Product Change Notification

Date February 23rd 2021
No. 028-21

TRACO POWER TEN 40E and TEN 40WIE series

Base plate preparation for additional heatsink mounting options

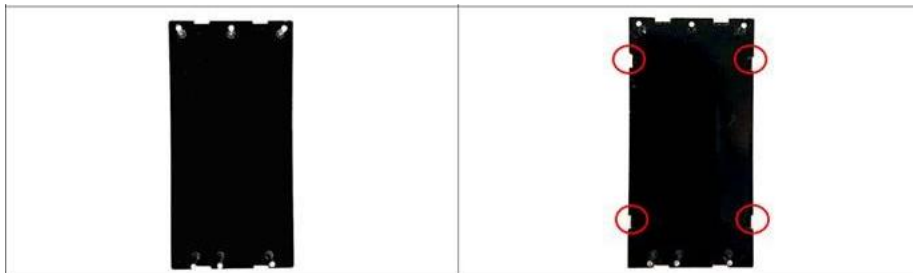
Subject product series have undergone a minor package design change. To be able to mount additional heatsink options the base plates of the TEN 40E and TEN 40WIE now received four additional slots for mounting clamps on the long sides.

Phased out package design

New package design

The exact positions of the new slots can be seen on the updated 3D-files online on our website: www.tracopower.com/overview/ten40wie
